CITY PLAN COMMISSION

FILE NUMBER: S234-069

REQUEST: An application to replat a 21.028-acre tract of land containing part of Lot 1 in City Block 4/7491 to create one lot on property located on Empress ROW at Viceroy Drive, west of Stemmons Freeway/Interstate Highway No. 35E.

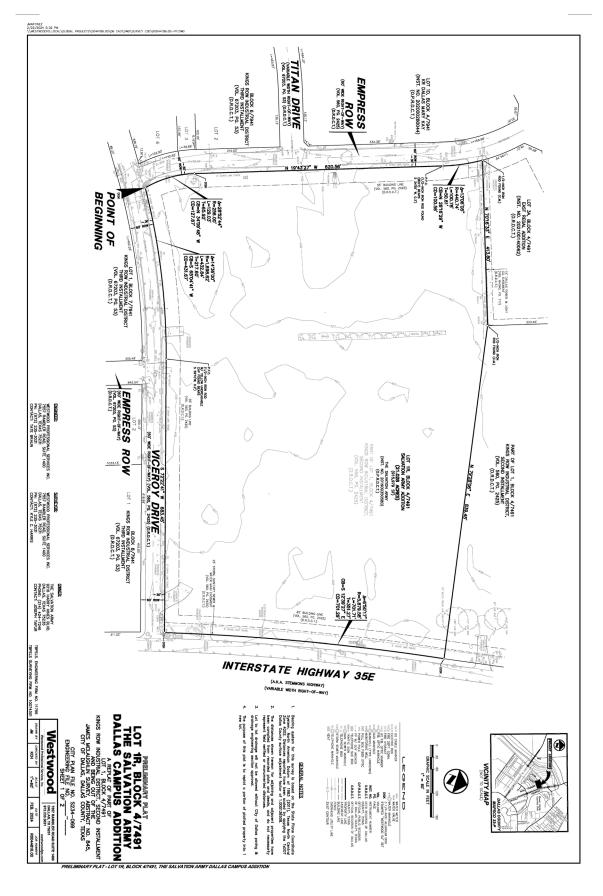
- 26. On the final plat, change "Interstate Highway 35E" to "Stemmons Freeway/Interstate Highway No. 35E".
- 27. Correct block number on plat to 4/7941.

- 28. On the final plat, change "Titan Drive" to "Titan Drive (AKA Titan ROW)".
- 29. On the final plat, identify the property as Lot 1C in City Block 4/7941.
